July 29, 2024

RE: The Prehn Family & NoCapX 2020 Scoping Comment
Wilmarth-N Rochester-Tremval a/k/a Mankato-Mississippi Transmission Line
PUC Dockets CN-22-532 and TL-23-157

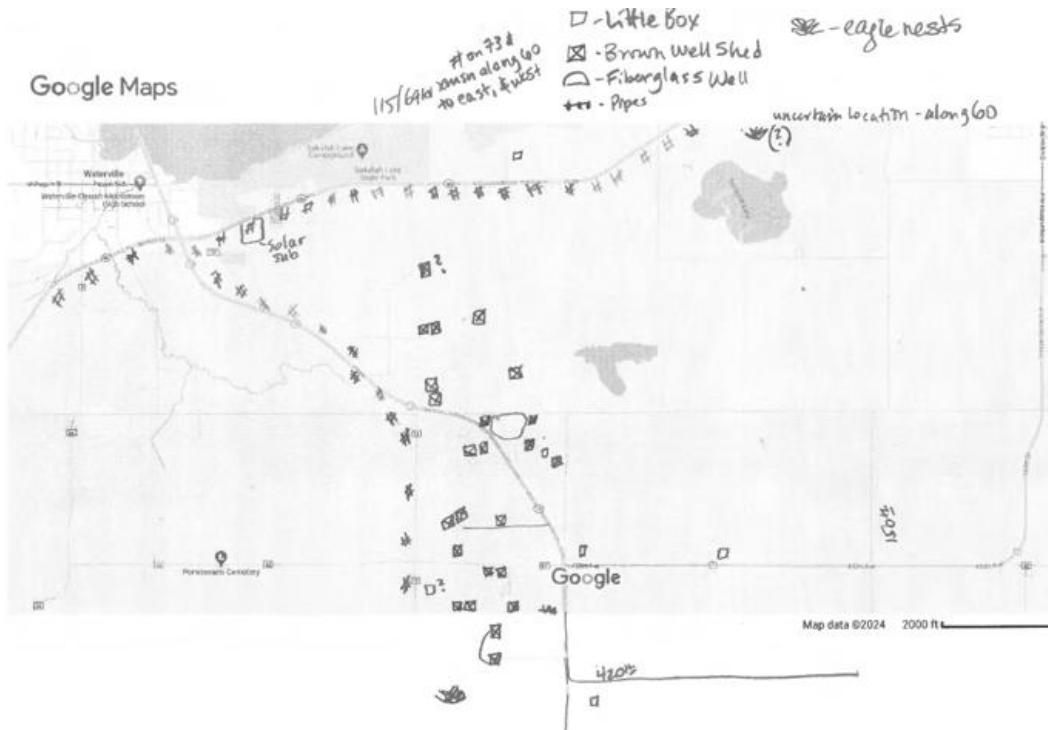
A map from the initial DNR permitting of the underground storage was included in the initial Prehn comment, and Xcel had the opportunity to review and mark it on its Segment 1 Map 8 map, and this was not done. These maps are from the mid-60s and 1972. The underground storage was expanded post 1972. I'd guess CenterPoint would provide a current map.

This is the very rough map compiled by the Prehns in an afternoon of area reconnaissance:

The EIS, with the help of CenterPoint and the Prehn’s map as guidance, must show the full extent of the CenterPoint natural gas dome on a map, the office and water treatment plant, and all of the wells and monitors in both of the routes, with particular designation for those wells and potentially affected areas and document its understanding of potential impacts.

DETAILED MAPBOOK: SEGMENT 1 (REVISED)

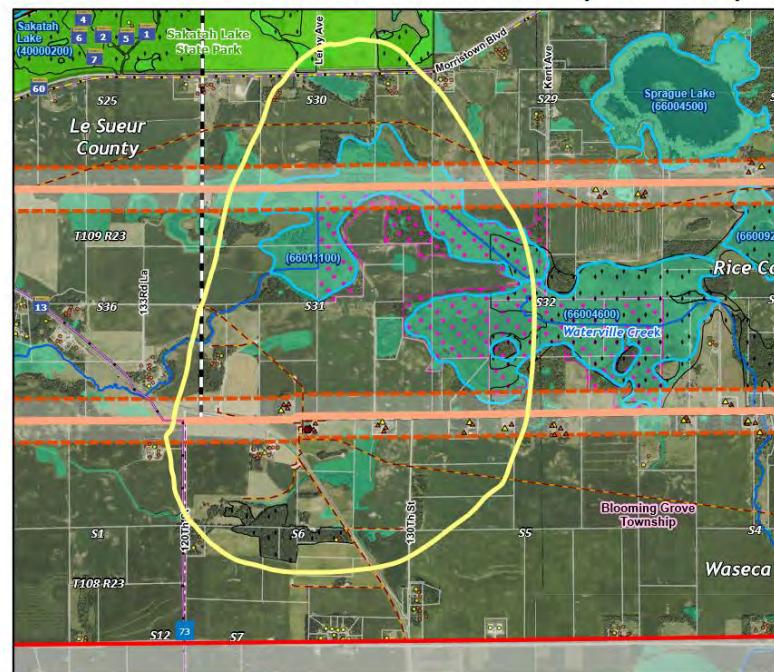
Xcel states that it has marked on its April 2024 revised map gas wells within 500 feet of the proposed line, identifying those wells with a black dot, but this writer cannot see any black dots on the map. Further, on April 2-24 Revised Segment 1 Map 8, there is no depiction of the extent of the natural gas storage dome, which is loosely represented by the yellow circle above and below. Xcel's revised map does show a large red dot at the CenterPoint office and water treatment plant along Highway 13, but again, that is just the office and water treatment facility, and not the gas dome. There is no depiction of the extent of the 13.25 square mile natural gas storage dome. By any measure, it's major infrastructure and should be shown on the map.

This is the Xcel's April 29, 2024 map with this writer's approximation of the dome boundary:

DETAILED MAPBOOK: SEGMENT 1 (REVISED MAY 6TH, 2024)

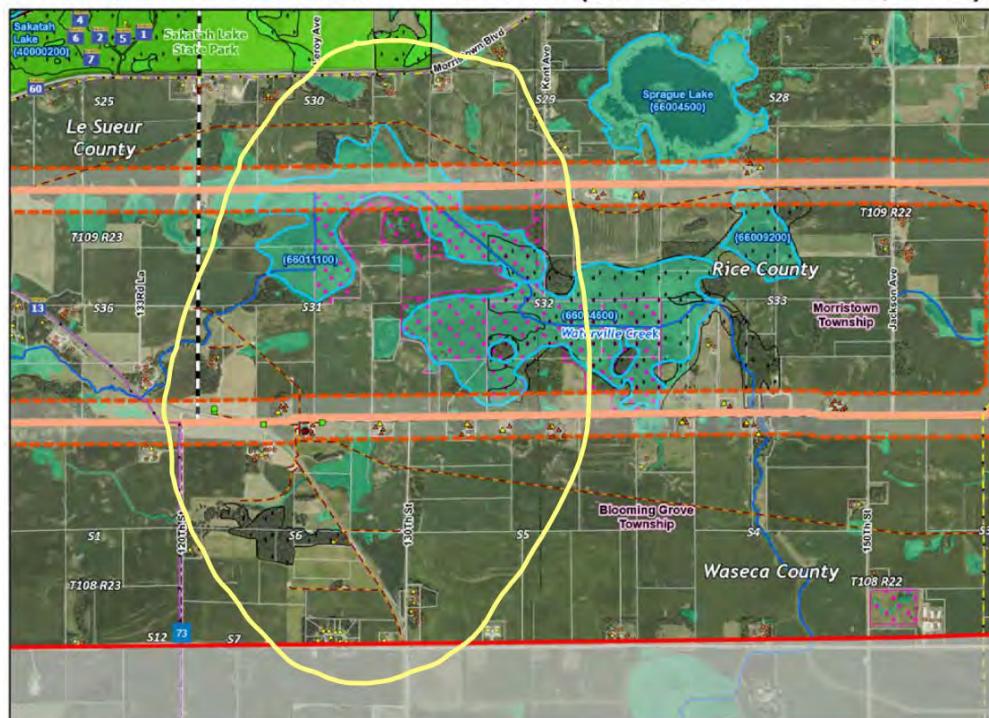
The May 6 revised map does show wells with green squares, but there are no wells marked on the northerly route, and there may well be some there. Again, there's no depiction of the gas dome, again with this writer's rough approximation of the dome boundary:

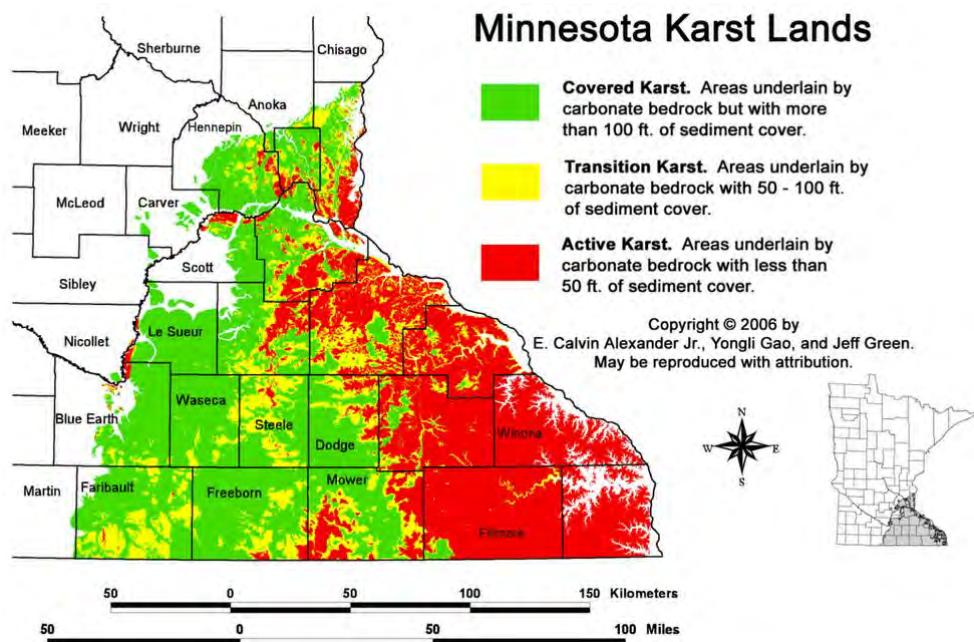
The EIS must map the active and transitional karst areas in the corridors where transmission structure foundations could be unstable³.

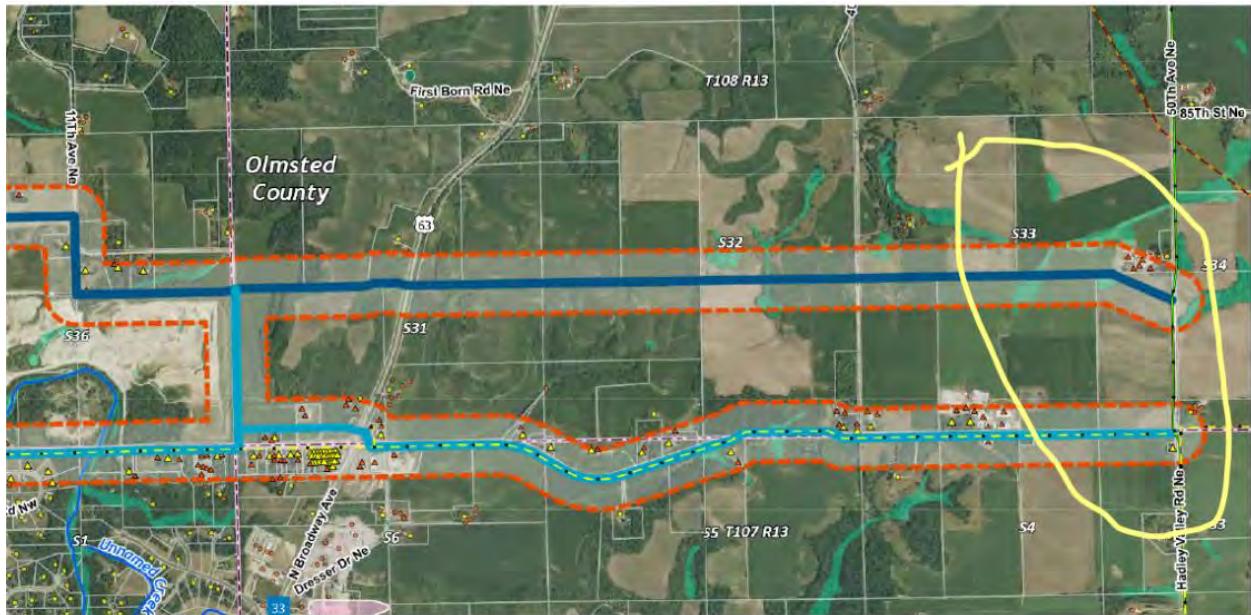
The EIS must disclose where the eastern end of the project extends beyond what is shown on the maps, which is two routes/corridors stopping at Hadley Valley Road N.E./50th Avenue N.E. where there is no substation or terminus of any sort. How the project transitions beyond what is on that map may well have, should have, an impact on what route is chosen. If a route is chosen without regard for how the line is routed beyond the map, it will lock that eastern “beyond” section of the 161kV project into a route that is not feasible or not recommended. The

Commission cannot make an informed decision without the remainder of the 161kV project in the record.
